AMENDED RECORD OF DECISION Tule Wind Project

Tule Wind Project
Decision to Amend Right-of-Way Grant

March 7, 2013

Proposed Action Title/Type: Tule Wind Modified 138 kV Transmission Gen-Tie

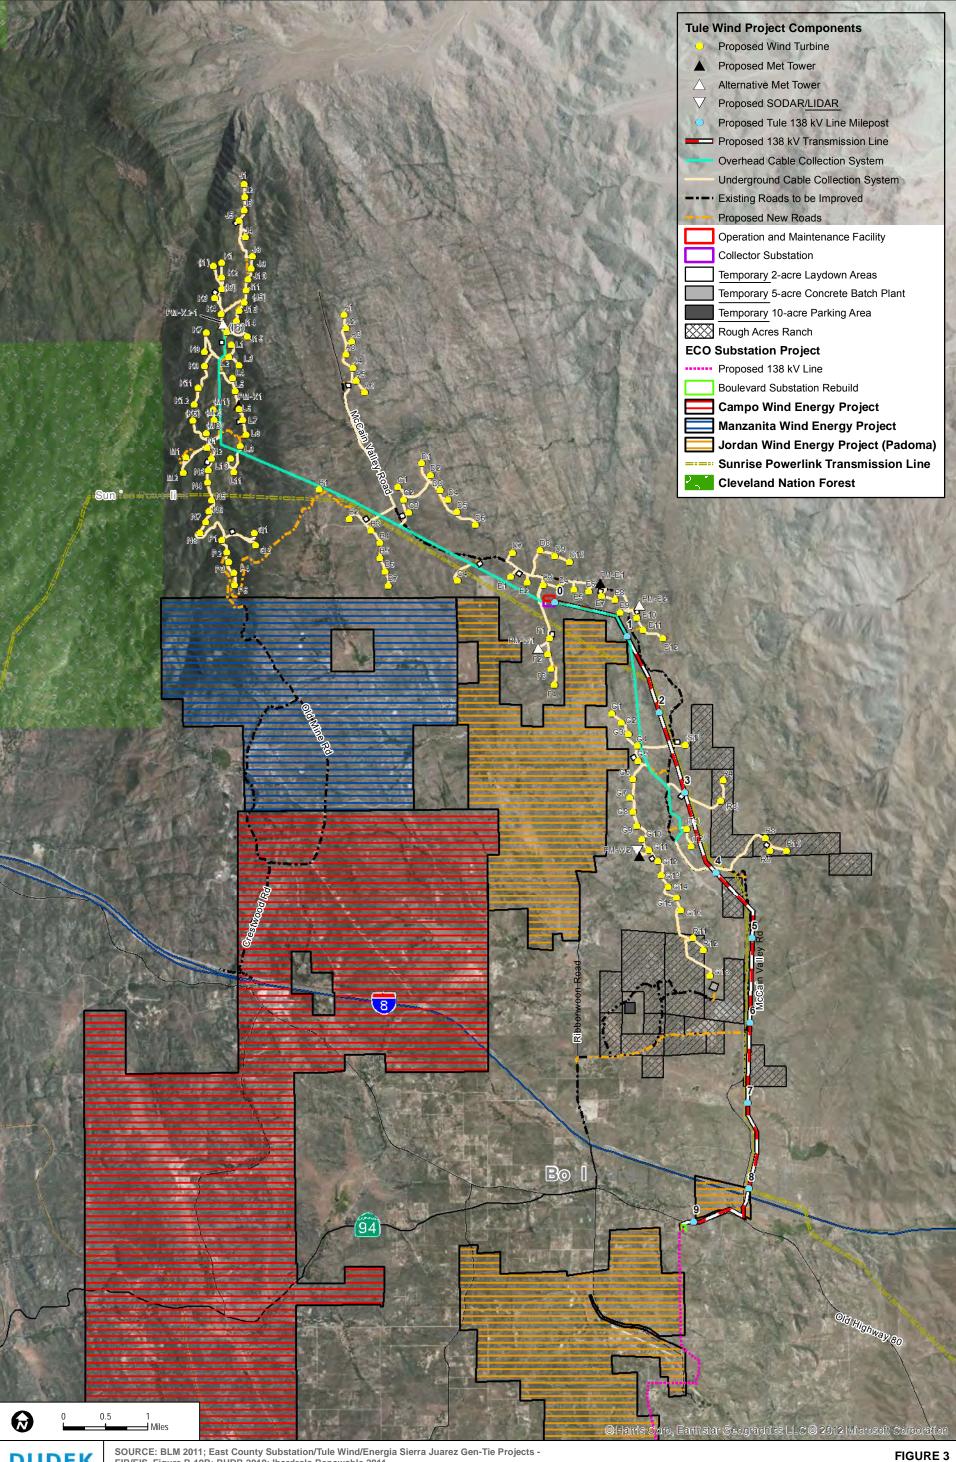
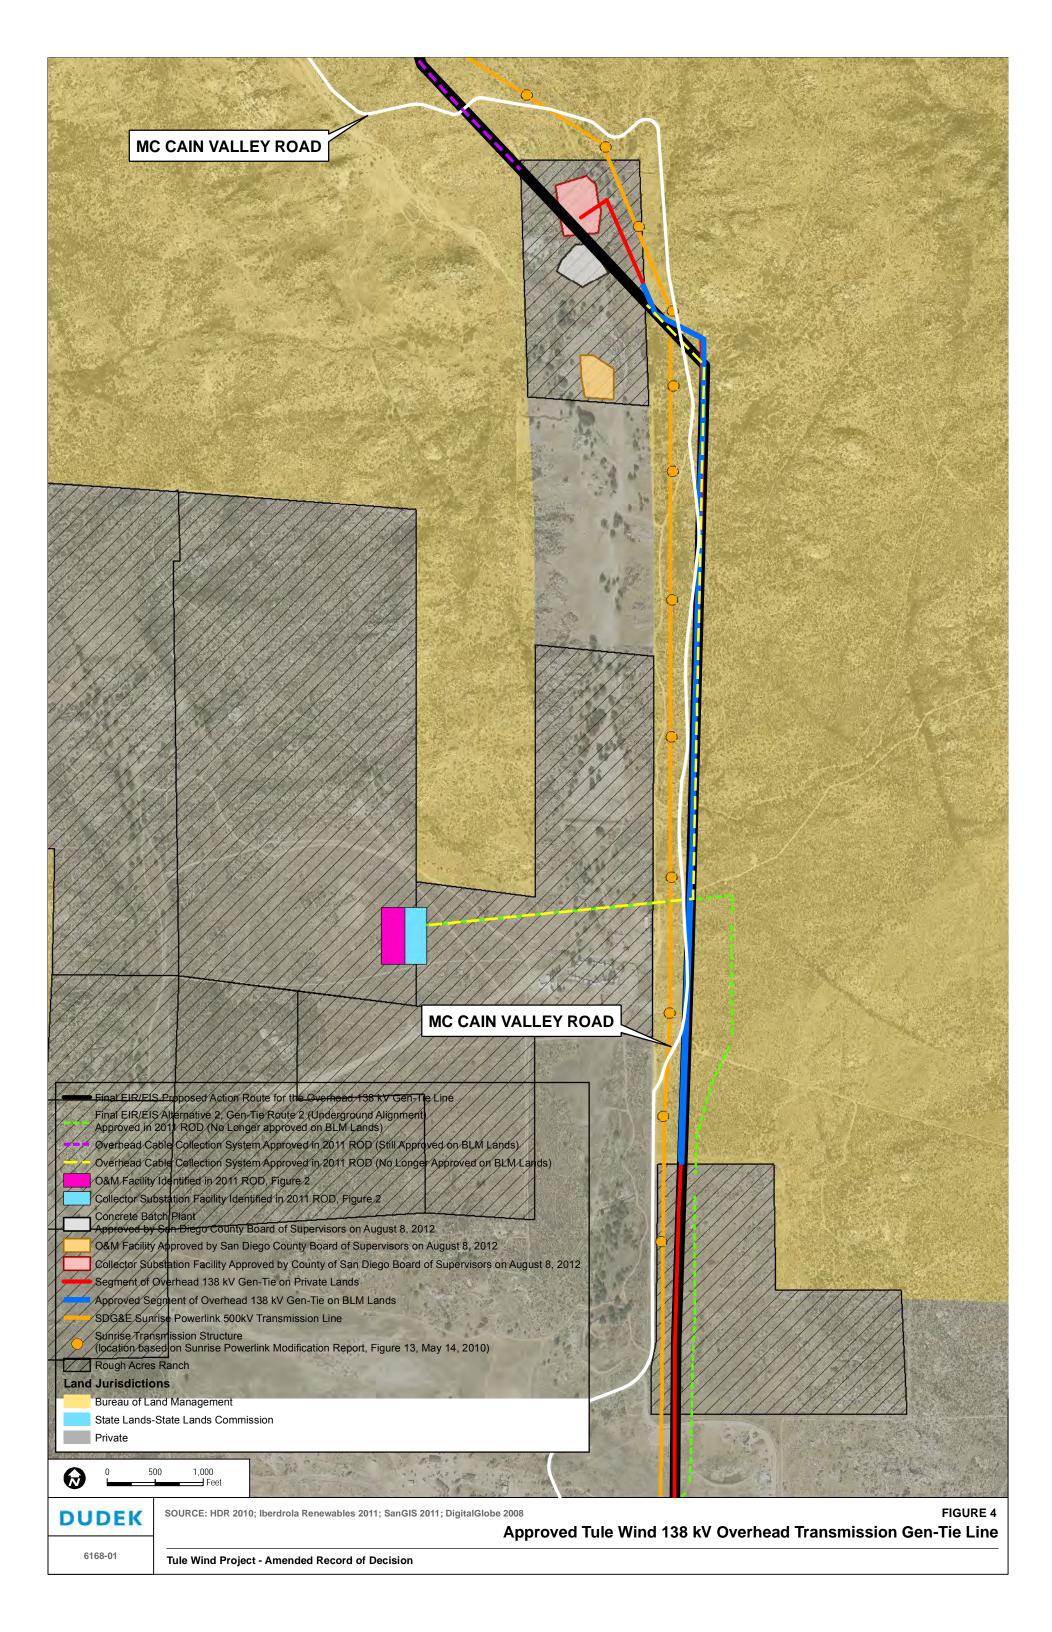
minor refinements, including: 1) a reduction of 4.14 miles of gen-tie line from that of the Proposed Action due to the change in collector substation location, and 2) a minor shift of an 1,100-foot segment of the gentie line from that of the Proposed Action to facilitate the gen-tie line tie-in to the approved collector substation (see Figure 4 of this Decision). Approval of the gen-tie component of the Proposed Action will allow construction of an overhead gen-tie line; whereas the currently approved Gen-Tie Route 2 would allow construction of an underground gen-tie line.

Because the San Diego County Board of Supervisors approved the collector substation on a different parcel of private land (south of the collector substation described in the Proposed Action and north of the parcel described in the Gen-Tie Route 2 alternative), the length of the gen-tie line will approximate 1.75 miles on public lands, and the alignment will be modified for an approximate 1,100-foot segment to accommodate the gen-tie line tie-in to the collector substation.² (See Figure 4 of this amended ROD.)
